Wisconsin Electric POWER COMPANY

April 28, 1975

DOCKET NOS. 50-266 AND 50-301
FLOODING RESULTING FROM FAILURES OF NON-CATEGORY I EQUIPMENT
POINT BEACH NUCLEAR PLANT - UNITS 1 AND 2

MTFB I

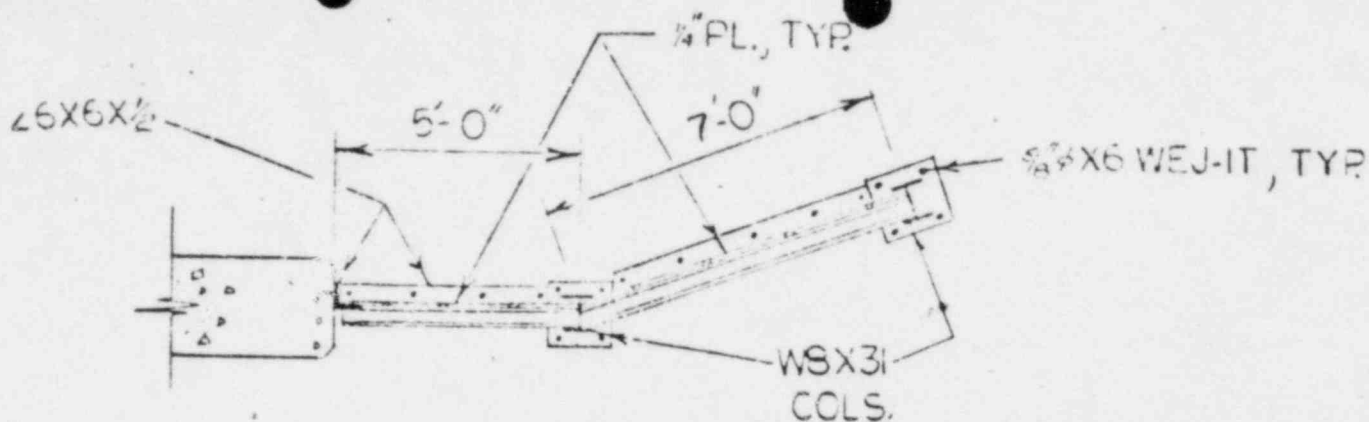
In our letter of February 17, 1975, we submitted an analysis of flooding potential from non-Category I systems and equipment at Point Beach Nuclear Plant, Units 1 and 2. With that submittal, we informed you of our intent to construct a flood barrier between monitor tank T10D and motor control center 2B42, to protect 2B42 from a possible rupture of the tank during a seismic event. The tank was not purchased as Category I equipment. Subsequently, during our review prior to fabrication of the barrier, we determined that the original configuration could not be installed with adequate strength to withstand the tank rupture. We have developed and are submitting herewith a revised design for the barrier, and we are currently in the process of purchasing material for the work.
